**DEPARTMENT OF PLANNING AND ZONING
PLANNER'S REPORT**

DATE: August 14, 2019
TO: Tonya Hutson
FROM: Lynn Patterson
RE: **Design Review – 3384 North Fulton Avenue**

The City of Hapeville has received a design review application from Janice M. White to construct a new one-story three bed, two bath single-family dwelling at 3384 North Fulton Avenue. The property is currently vacant, although there is already an existing driveway and curb cut. The dwelling will have 1,528 SF of heated floor area and will provide off-street parking via a 10' wide driveway along the south side of the house.

Elevation View

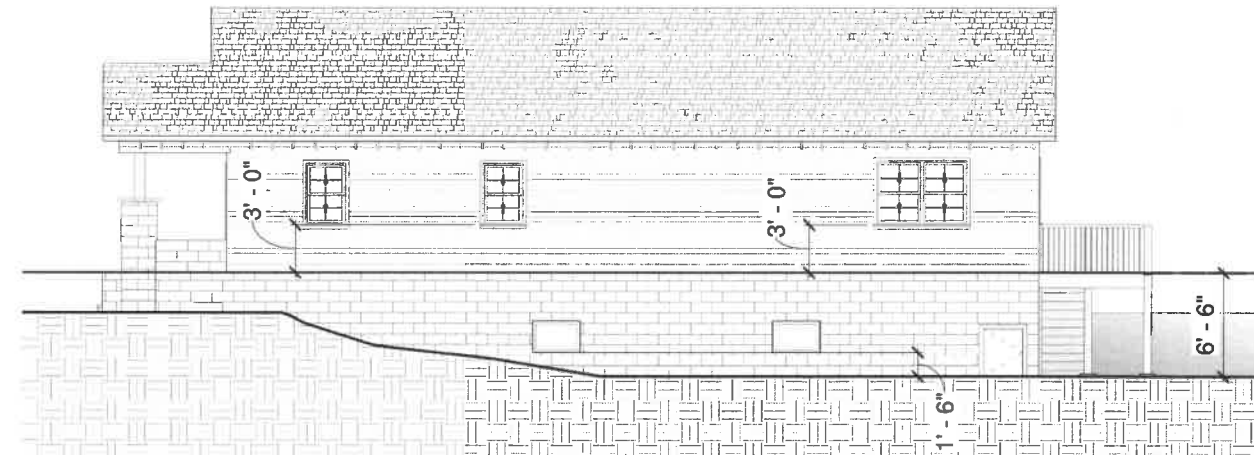
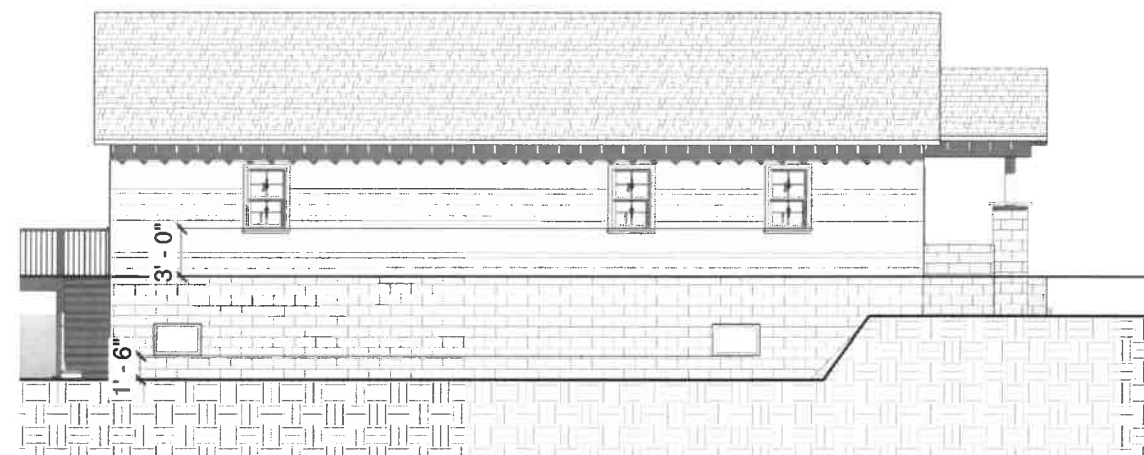
- STAFF COMMENT:**
- The applicant should ensure the roof shingles have a minimum usable life of 30 years per manufacturer's warranty.
 - The applicant should specify the distance the roof overhangs the facades of the house, ensuring it is at least 12".
 - The plans should be revised to describe the material of the gutters and downspouts and to show them on the elevations.

- While the front porch appears to be constructed of stone or brick and wood, the applicant should clarify the materials used in the porch.
- Front porches must have a minimum depth of 8' from façade to the outside of the columns. While the distance to the outside of the columns has not been provided, it appears to be less than 8', which is not compliant.
- The front porch is 51% of the width of the adjacent facade. The standards state porches must be at least 80% of the facade width; however, the size of the porch is consistent with the encouraged Craftsman style and may be permissible with a design exception.
- Front porch columns must be spaced a maximum of 8' on center. While the distance between the columns has not been provided, they appear to be wider than 8' apart, which is not compliant and, if approved, would require a design exception.

- Building numbers at least 6" in height on the porch or adjacent to the front door should be included and shown on the plans.
- The provided window schedule does not match the floor plan designations.
- The applicant should ensure no GBGs will be utilized.
- Windows must comply with all requirements of Sec. 81-1-7(g) - *Door and window standards*. The elevations should be revised to demonstrate compliance and the plans should provide the following information:
 - Window pane recession from adjacent facades
 - Trim width, depth, and material
 - The width of mullions between grouped windows
 - The height and width of all street facing windows
 - Window sill materials

- The dwelling is a Craftsman-style home. The plans show a porch extending about one-half of the building, which is compliant with this style. However, one of the support columns is offset from the right side of the porch, which creates an asymmetrical appearance and is not traditional for the style. To fully comply with the style, the applicant should move the right support column over to the edge of the porch.
- The applicant should provide the thickness of the porch support columns at their smallest point.

7. The plans should be revised to describe the material of the gutters and downspouts and to show them on the elevations.
8. While the front porch appears to be constructed of stone or brick and wood, the applicant should clarify the materials used in the porch.

9. Front porches must have a minimum depth of 8' from façade to the outside of the columns. While the distance to the outside of the columns has not been provided, it appears to be less than 8', which is not compliant.

10. The front porch is 51% of the width of the adjacent facade. The standards state porches must be at least 80% of the facade width; however, the size of the porch is consistent with the encouraged Craftsman style and may be permissible with a design exception.

11. Front porch columns must be spaced a maximum of 8' on center. While the distance between the columns has not been provided, they appear to be wider than 8' apart, which is not compliant and, if approved, would require a design exception.

14. The applicant should ensure no GBGs will be utilized.
15. Windows must comply with all requirements of Sec. 81-1-7(g) - *Door and window standards*. The elevations should be revised to demonstrate compliance and the plans should provide the following information:

- a. Window pane recession from adjacent facades
 - b. Trim width, depth, and material
 - c. The width of mullions between grouped windows
 - d. The height and width of all street facing windows

- e. Window sill materials
16. The dwelling is a Craftsman-style home. The plans show a porch extending about one-half of the building, which is compliant with this style. However, one of the support columns is offset from the right side of the porch, which creates an asymmetrical appearance and is not traditional for the style. To fully comply with the style, the applicant should move the right support column over to the edge of the porch.

17. The applicant should provide the thickness of the porch support columns at their smallest point.
